DIXIE-NARCO, INC.
SERVICE BULLETIN #120

MODELS: All Executive Venders
Mark III & IVD Venders

REASON: To provide a more durable coin insert casting.

SUBJECT: Installation Instructions

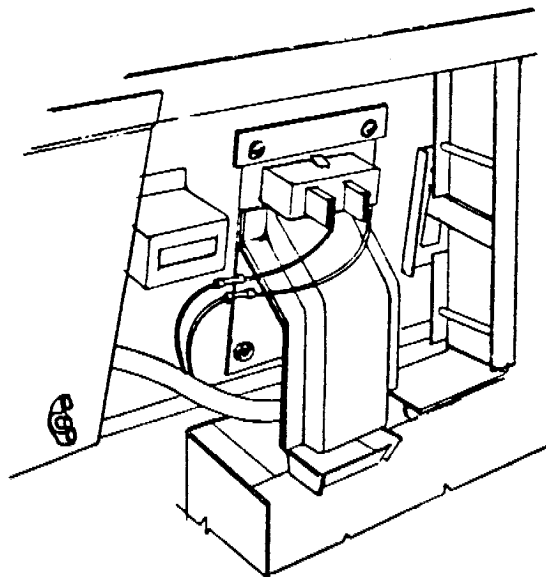
1. Remove plastic coin insert and coin chute. Remove correct change lamp and bracket, cutting leads from lamp socket. Strip & twist correct change lamp leads remaining on harness to fit butt connectors (on leads from new lamp).
2. Install die cast coin insert, securing in place with new coin chute bracket, keps nuts, and two tee bolts through bottom holes in casting. Secure top corners with retainer strip and sheet metal screws.
3. Join butt connectors on lamp leads to lamp lead wires in harness by crimping.
4. Check alignment of bottom of coin chute with hopper on changer. Coin chute bracket may be bent to align chute with hopper.
5. Apply new instruction sign.
